Appendix A
Correspondence
(includes unsigned EPA correspondence)

**Summary of Correspondence
Air Quality Monitoring Program
Yerington Mine Site**

RE: Revised Review Comments on *Draft Air Quality Monitoring Work Plan*, submitted by Atlantic Richfield Company, dated December 21, 2004
Anaconda Copper Mine Site, Yerington, Nevada

Subject: Response to Comments on the Draft Air Quality Monitoring Work Plan

Figure 1
Air Quality Monitoring Locations

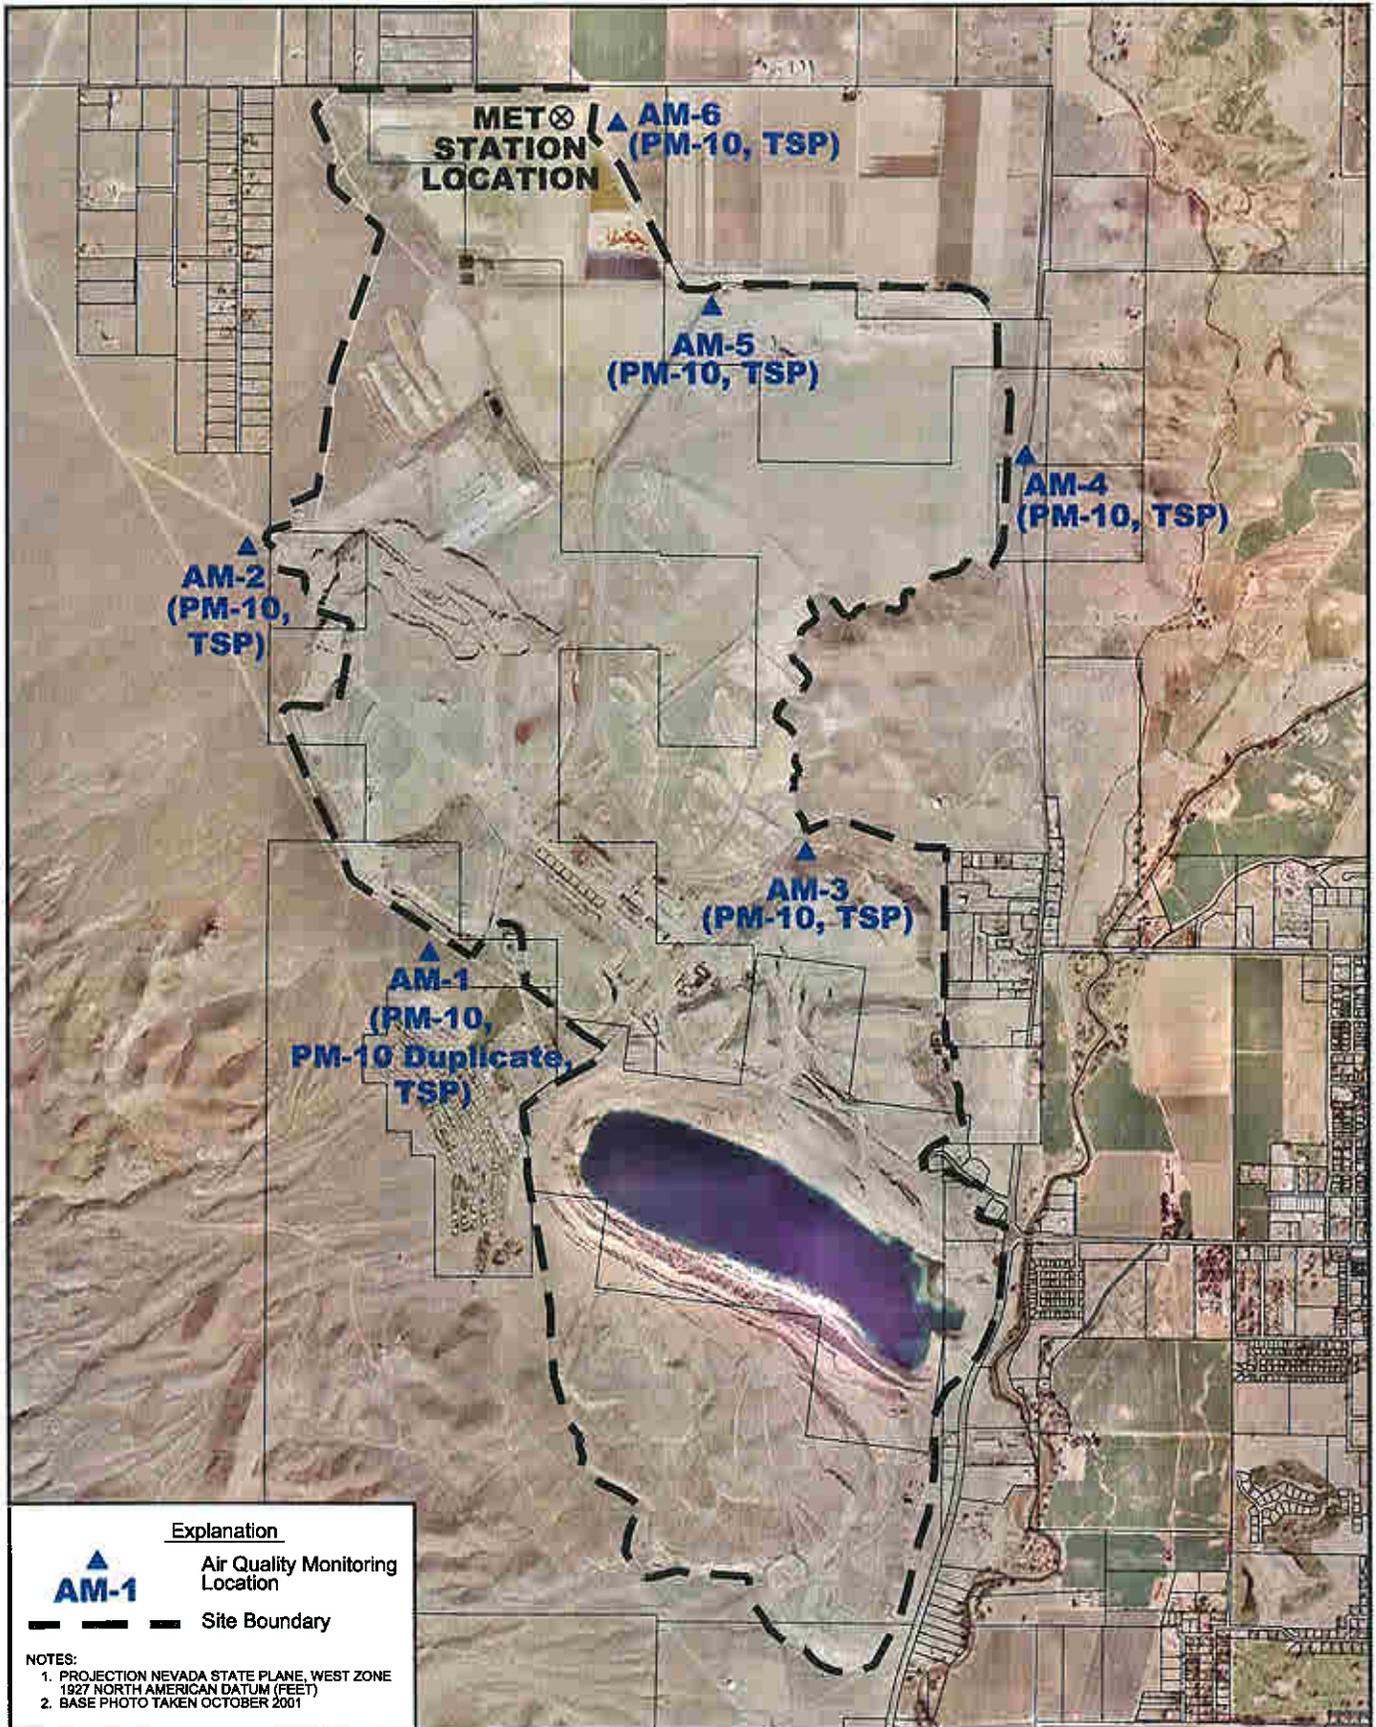
Comment 21. Figure 1 should include the location of the meteorological tower.

Comment 1. [Section 2.0, Monitoring Locations and Equipment; Figure 1, Air Quality Monitoring Locations] Section 2.0 describes where the meteorological station is located. It is recommended that this be included on Figure 1.

Response to Comment 21. Figure 1 has been changed to include the location of the meteorological tower.

Response to Comment 1. Figure 1 has been changed to include the location of the meteorological tower.
